KENWOOD

ASB-1006

Service Bulletin

Subject: TS-850S Low/no Receiver Sensitivity

RF Unit (X44-3120-00)

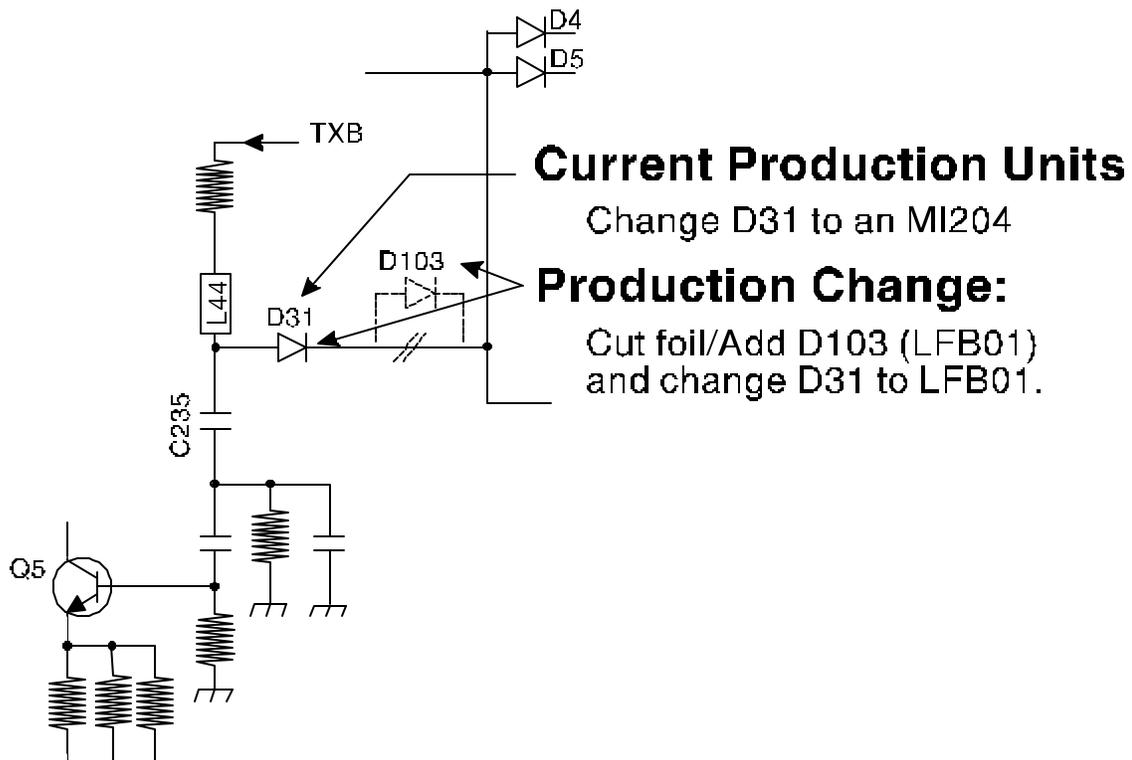
Reports of low or no receiver sensitivity accompanied by a lack of audio from the speaker during CW or SSB modes might be caused by improper RXB voltage levels. Normal RXB voltage is +8 vdc during receive and 0 vdc during transmit. If you find approximately +2 vdc during receive you might suspect a problem with a leaking diode, D31 on the RF unit (X44-3120-00.)

D31 is used as the transmit switching diode. Leakage of this diode is most probably caused by electrostatic surge or discharges from the antenna.

A temporary cure for units that have already been manufactured is to replace D31 with an MI204 diode. Future production radios will change D31 to an LFB01 diode and incorporate a change in the printed circuit foil pattern to allow addition of a series diode, D103 (LFB01).
